**MILESTONE INNOVATION CENTER: PRELIMINARY PLAN AMENDMENT
NO. 11987271D & SITE PLAN AMENDMENT NO. 82001009G**

Amendments to allow 308,500 square feet of Research and Development and 161,500 square feet of Office uses in 3 new buildings.

Nos. 11987271D & 82001009G

Completed: 3-7-2022

Figure 11 – Proposed Landscape Plan

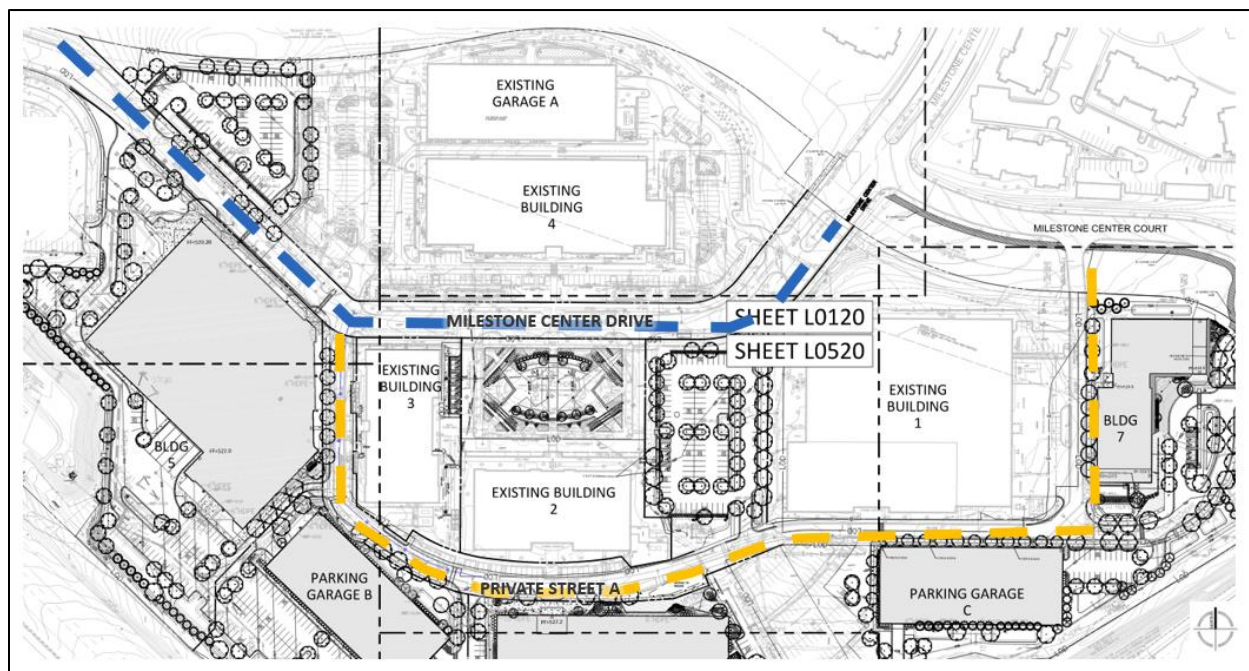
The Applicant does not demonstrate adequate street trees along Milestone Center Drive (highlighted in blue) and Private Street A (highlighted in yellow) as shown in Figure 11 below. As conditioned, the Applicant will resolve this issue prior to the certification of the Site Plan.

- b) The streetscapes for Milestone Center Drive and Private Street A must include tree planting strip or tree boxes with shade trees, as approved by Planning Staff.

Figure 16 – Recommended Sidewalk Connection (highlighted in yellow)

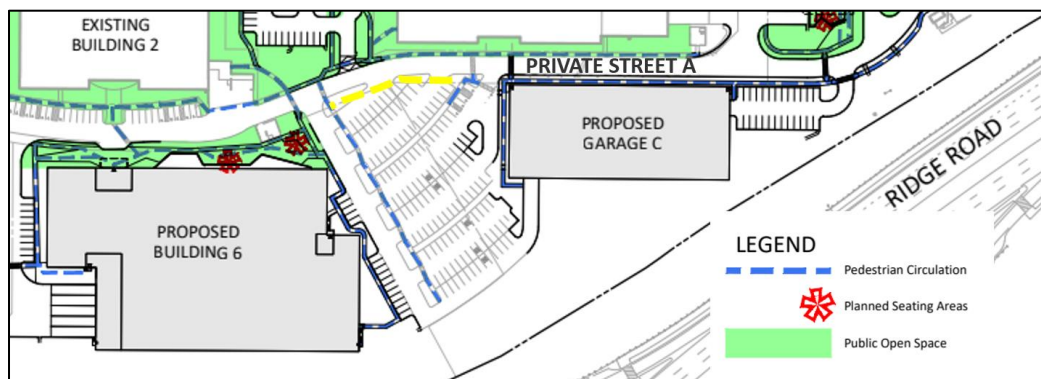
The proposed development provides safe, well-integrated parking and circulation. The proposed office and research and development buildings will have a mix of surface and garage parking served by Milestone Center Drive, Milestone Center Court and Private Street A. Pedestrian circulation will also be improved along Milestone Center Court with the construction of a sidewalk along the south side as well as the completion of a sidewalk along the north side. A new drive aisle will be constructed to serve the surface parking lot between existing Building 2 and Building 1. This drive aisle will include sidewalk and street trees to provide a street-like environment while improving north/south pedestrian movement through the property. As conditioned, the wide loading bays for existing Buildings 2 and 3 will be improved with stamped concrete and new pedestrian markings, with the design to be reviewed and approved by Planning Staff. Also, as conditioned, a sidewalk is recommended between Building 6 and Garage C along Private Street A and a paved recreation trail is recommended within the existing transit easement on the northern edge of the Property. These pedestrian connections will contribute towards adequate, safe and efficient circulation as shown in Figure 16 and 17.

- n) Revise applicable plan sheets to include a sidewalk segment along Private Street A between Building 6 and Garage C.
 - o) Ensure consistency between the data table in the Staff Report and the Preliminary and Site Plan drawings.
